REVIEW of RI/FS WORK on the ACME SOLVENTS SITE

REVIEW OF THE RI/FS REPORT
ON THE ACME SOLVENTS SITE

FOR THE
ACME TECHNICAL COMMITTEE

PREPARED BY
EUGENE A. HICKOK AND ASSOCIATES
WAYZATA, MINNESOTA 55391

ACME SOLVENTS SUPERFUND SITE	E.A. HICKOK & ASSOCIATES	MAR.1985
DEEP WELL WATER LEVELS - APRIL 26, 1984	HYDROLOGISTS-ENGINEERS MINNEAPOLIS-MINNESOTA	2.20

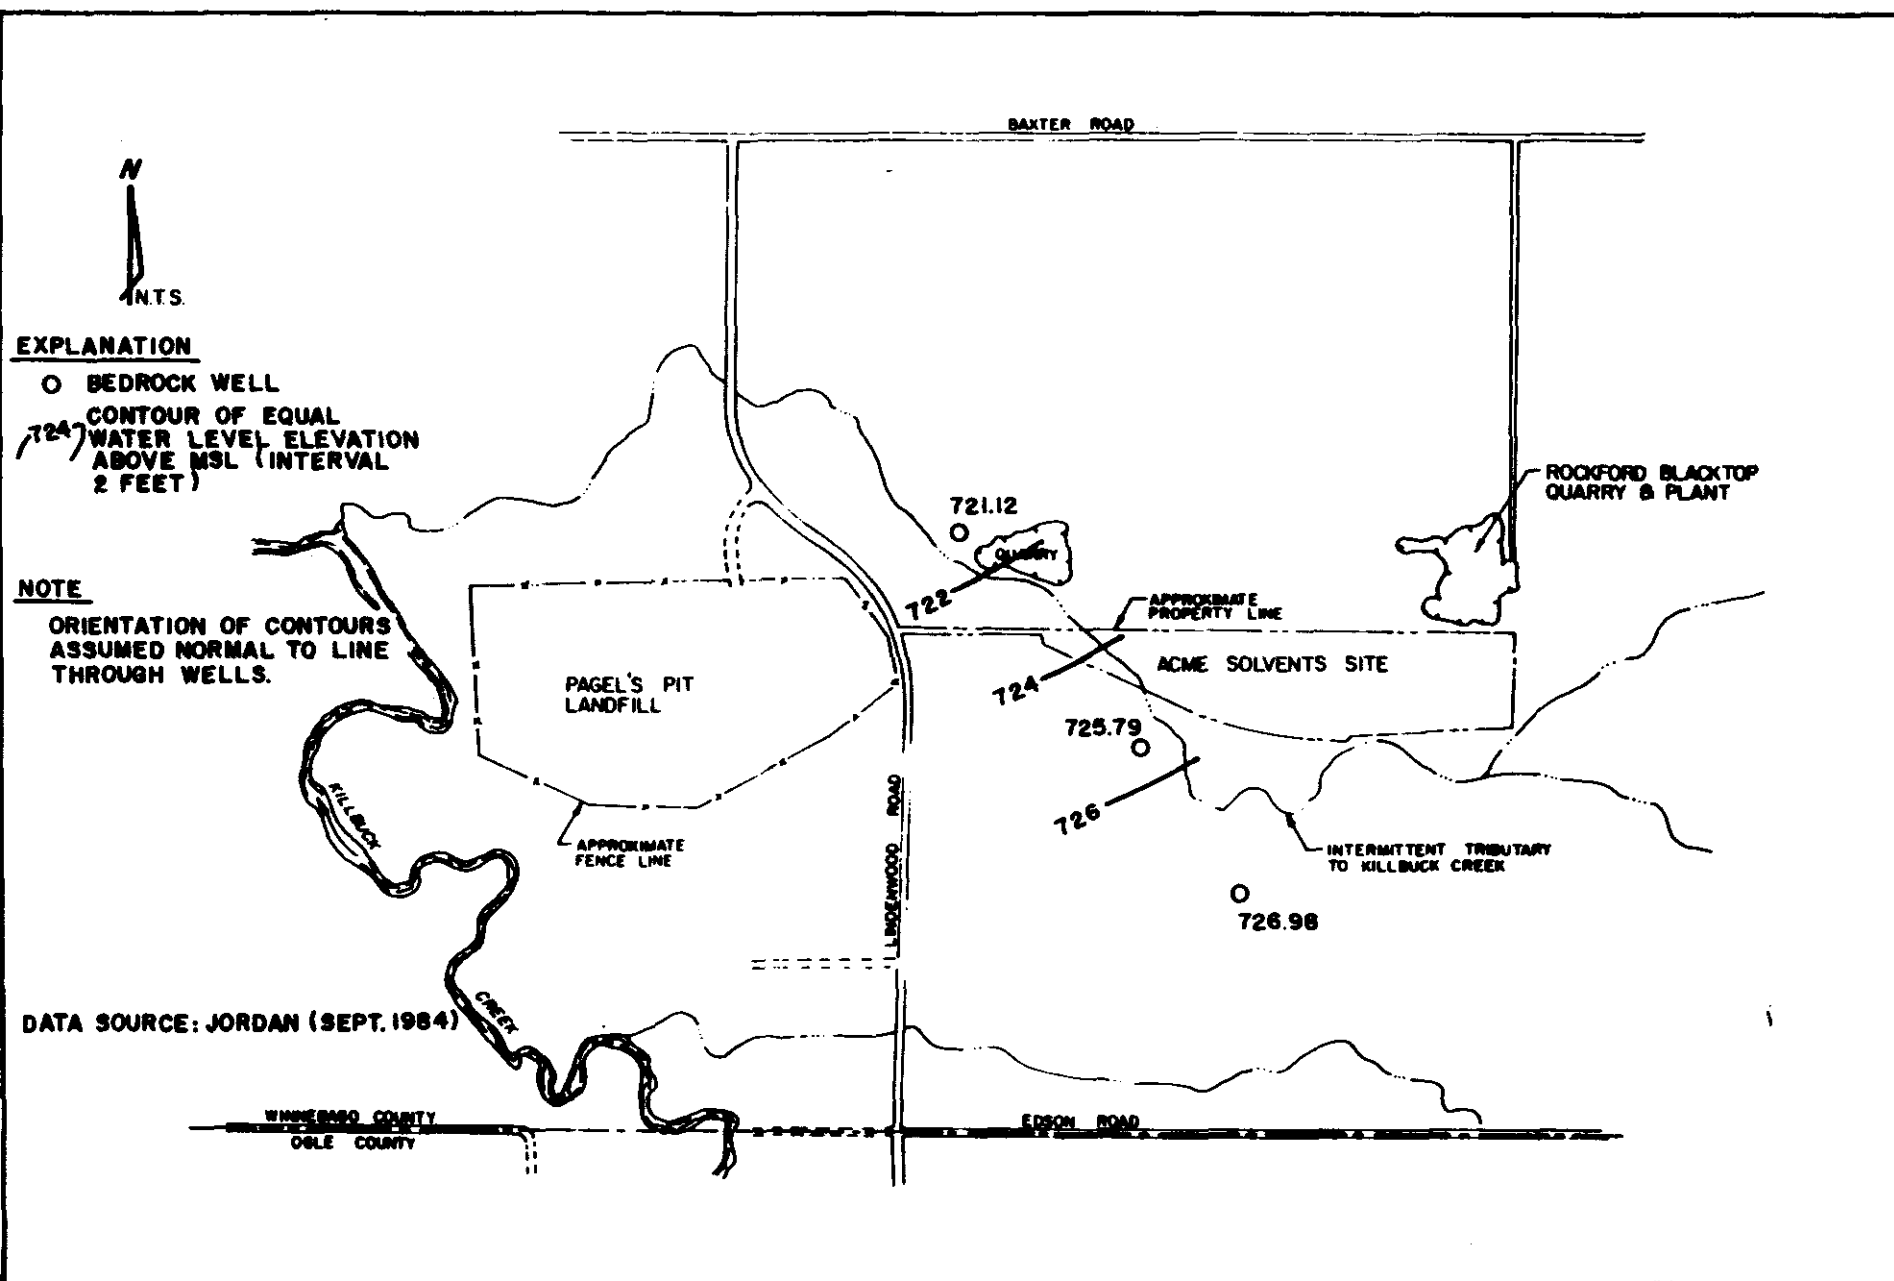
From Figure 2.20, the horizontal flow pattern in the deep stratum appears to be radically different from the pattern at shallower depths (Note again that the "deep" wells in the RI penetrated only the upper half of the shallow aquifer. The terms "deep stratum" and "deep wells" are used relatively in this memorandum.) With only three deep wells, and with the wells in a linear configuration, it is possible only to determine one component of gradient and flow.

In Figure 2.20 the known component of gradient is northwestward and is on the order of 0.003 feet per foot. Deep-well data from March and earlier in April give the same results. There is a corresponding northwestward flow component. However, additional deep wells could reveal an overall gradient (and flow direction) that is either more northerly or more westerly than that shown in Figure 2.20. A westward flow direction would be easier to reconcile with the shallow data.
